Docket Nos. 50-280
and 50-281 ✓

Licenses Nos. DPR-32
and DPR-37

Change No. 9

2.0 SAFETY LIMITS AND LIMITING SAFETY SYSTEM SETTINGS

Figure 2.1-1 Reactor Core Thermal & Hydraulic Safety Limits - Three Loop Operation, 100% Flow

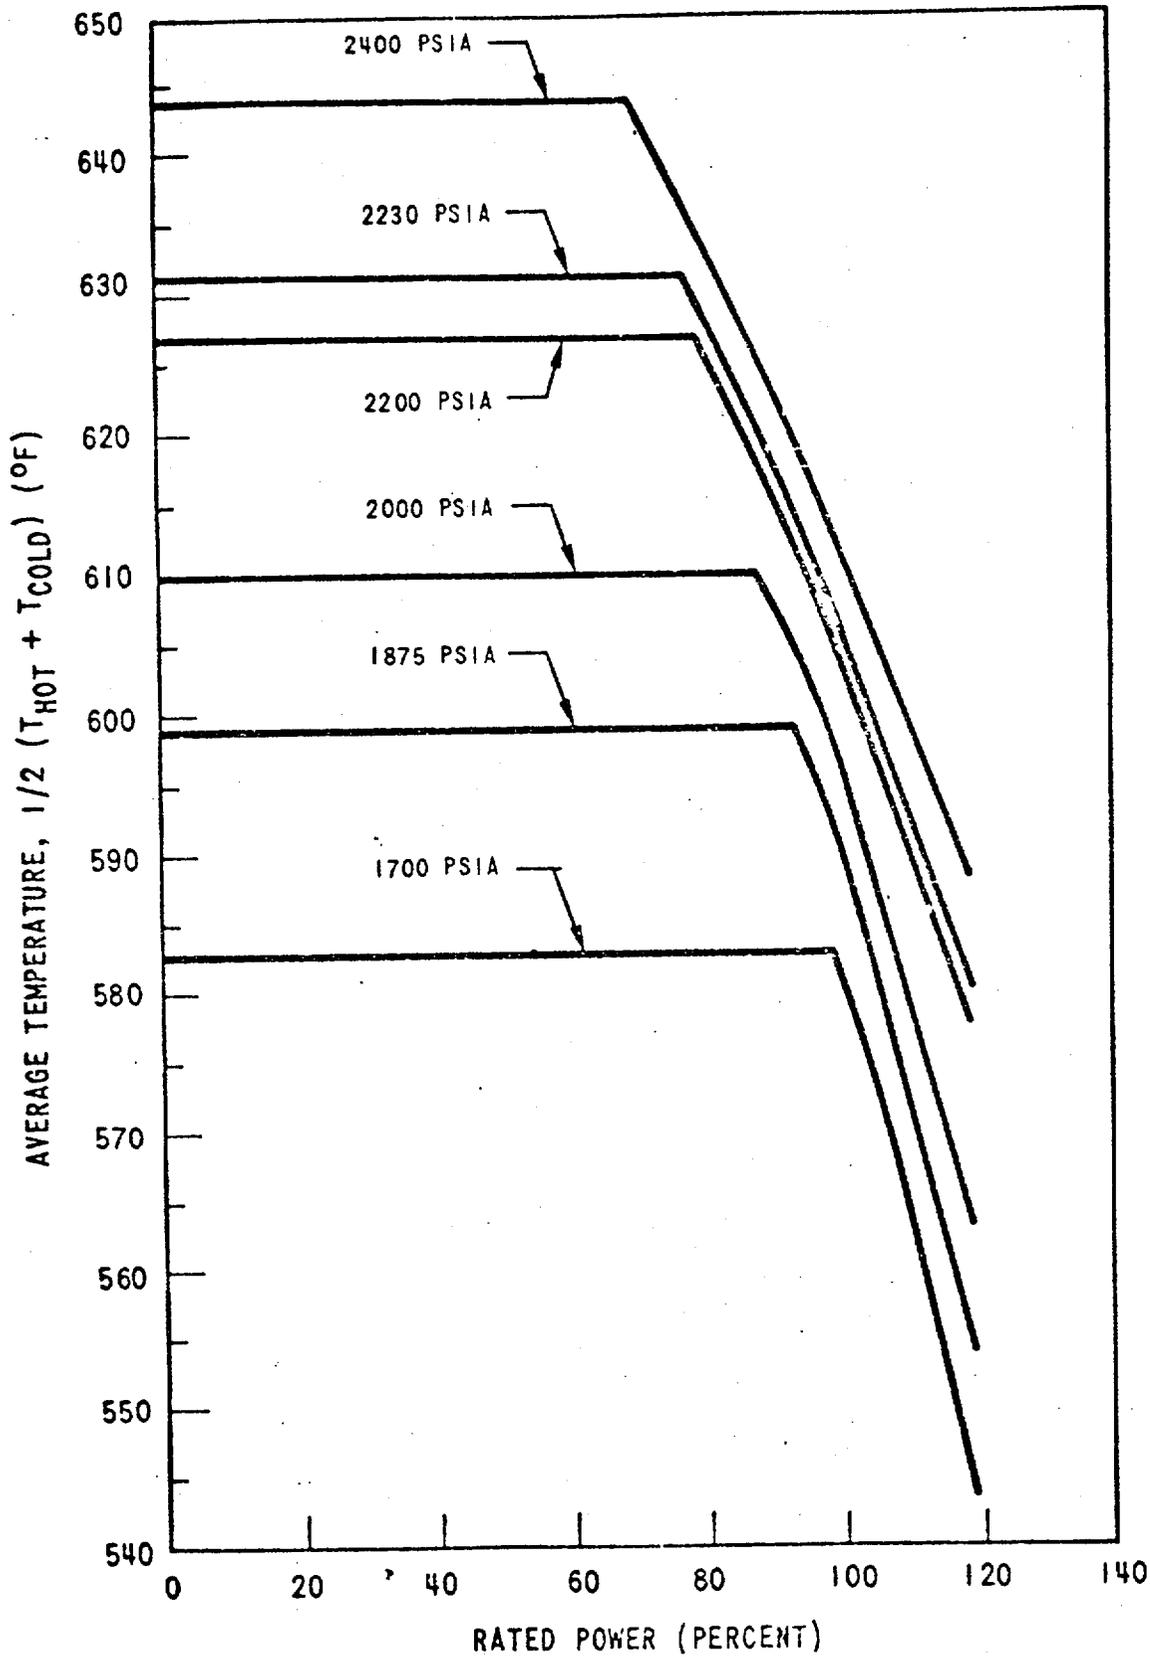
The curves of TS Figure 2.1-1 which show the allowable power level decreasing with increasing temperature at selected pressures for constant flow (three loop operation) represent the loci of points of thermal power, coolant system average temperature, and coolant system pressure for which the DNB ratio is not less than 1.30. The area where clad integrity is assured is below these lines. In order to completely specify limits at all power levels, arbitrary constant upper limits of average temperature are shown for each pressure at powers lower than approximately 75% of rated power. The temperature limits at low power are considerably more conservative than would be required if they were based upon a minimum DNB ratio of 1.30 but are such that the plant conditions required to violate the limits are precluded by the self actuated safety valves on the steam generators. The three loop operation safety limit curve has been revised to allow for heat flux peaking effects due to fuel densification.

TS Figure 2.1-2 and 2.1-3 have not been revised as these have been found to be adequate and conservative even including the effects of densification. Figure 2.1-1, 2 and 3 also include an allowance for an increase in the enthalpy rise hot channel factor at reduced power based on the expression:

Figure 2.3-1. Limiting Safety System Setting for High Flux and Overpower ΔT Trips versus Fuel Burnup

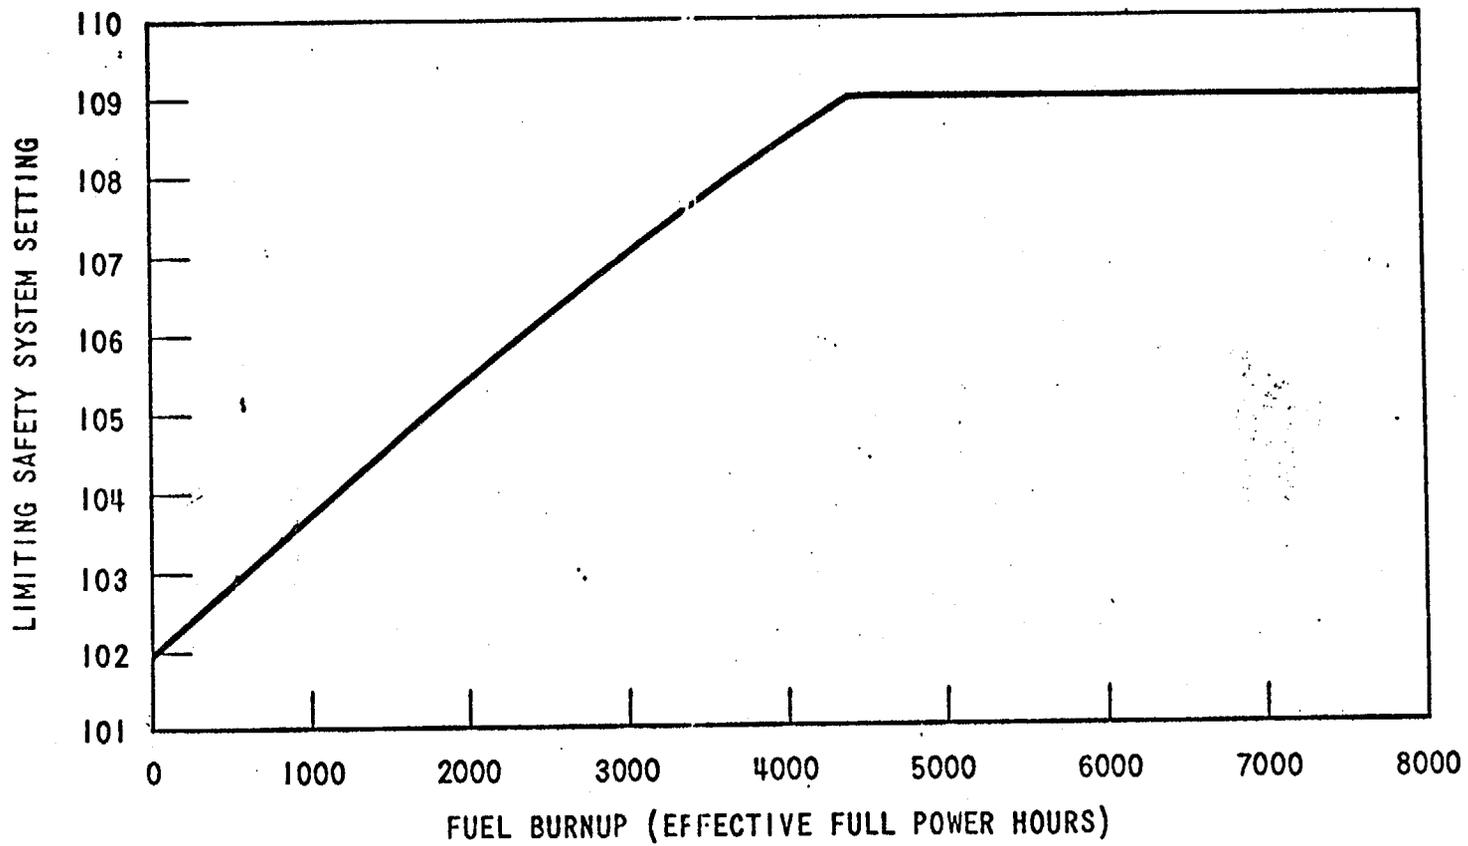
= value shown in TS Figure 2.3-1 at intervals subsequent to beginning of core life determined at intervals no more frequent than 750 EFPH.

TS FIGURE 3.12-8
PERMITTED POWER TO HEET LCA
CRITERIA AND BURNUP

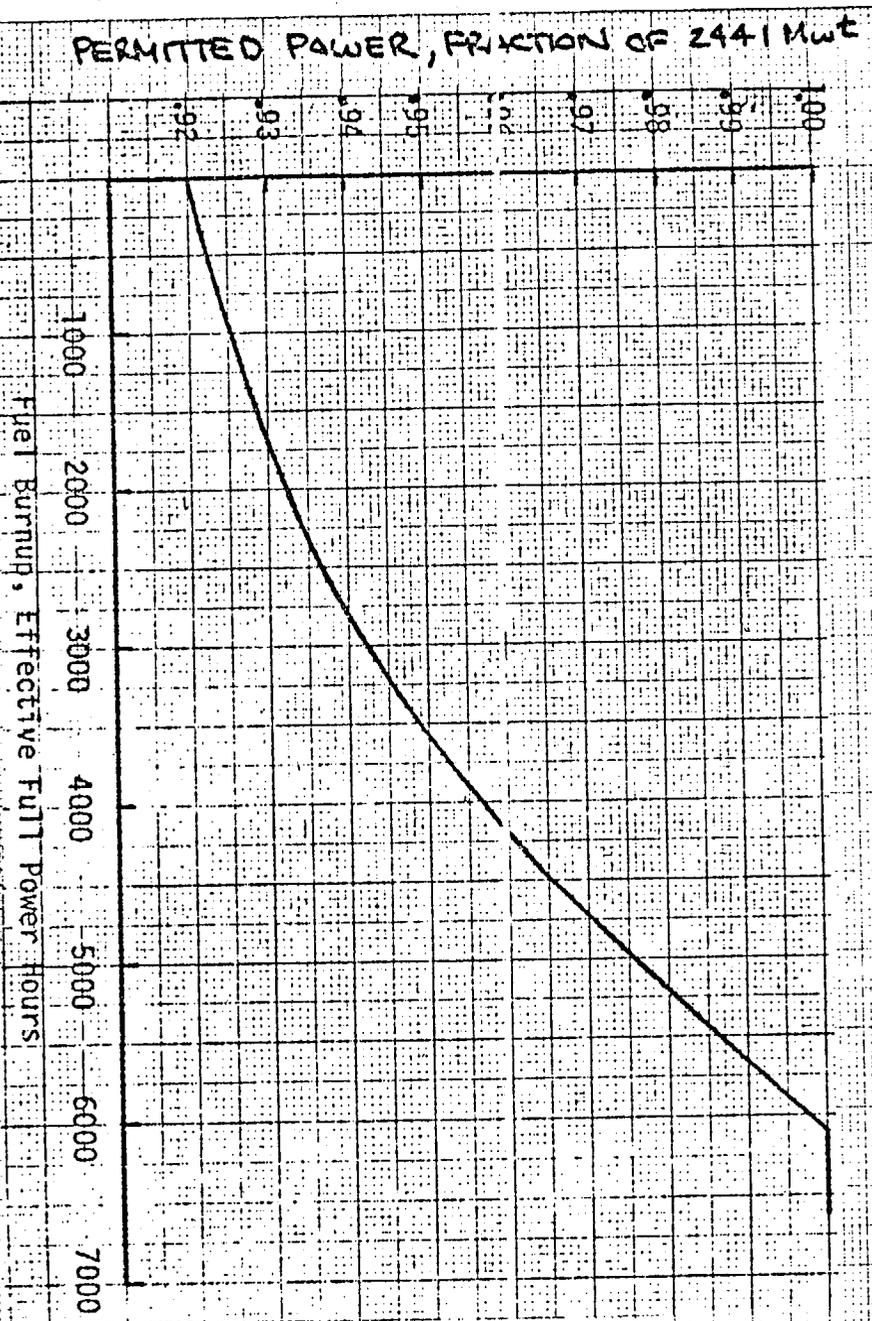
On the basis of our review, we have determined that, for this power escalation, the three areas requiring assessment were minimum DNBR ratio (DNBR), stored energy, and creep collapse. The DNBR analysis was performed using the methods as described in the FSAR for 100% of rated power. The minimum value of the DNBR ratio during normal operation and anticipated transients is limited to 1.30. Since the calculated DNBR is above this limit for power operation up to 100% of rated power, including anticipated transients, we find this acceptable. We have reviewed the Westinghouse time dependent creep collapse and stored energy models and find them acceptable for a fuel residence time of 10,000 EFPH. We have determined that the effects of fuel densification and reduced primary coolant system pressure above 92% of rated power have been adequately analyzed for a fuel residence time of 10,000 EFPH and that the plant power capability, with respect to such effects, is acceptably defined in Figure 3.12-8 of

On the basis of our review, we have determined that, for this power escalation, the three areas requiring assessment were minimum DNBR ratio (DNBR), stored energy, and creep collapse. The DNBR analysis was performed using the methods as described in the FSAR for 100% of rated power. The minimum value of the DNBR ratio during normal operation and anticipated transients is limited to 1.30. Since the calculated DNBR is above this limit for power operation up to 100% of rated power, including anticipated transients, we find this acceptable. We have reviewed the Westinghouse time dependent creep collapse and stored energy models and find them acceptable for a fuel residence time of 10,000 EFPH. We have determined that the effects of fuel densification and reduced primary coolant system pressure above 92% of rated power have been adequately analyzed for a fuel residence time of 10,000 EFPH and that the plant power capability, with respect to such effects, is acceptably defined in Figure 3.12-5 of

the Technical Specifications and therefore, operation at 100% of rated power at a reduced primary system pressure of 2000 psia is permitted. We have also determined that the proposed incore surveillance program provides the necessary assurance that the reactor will be operated within the prescribed limits.
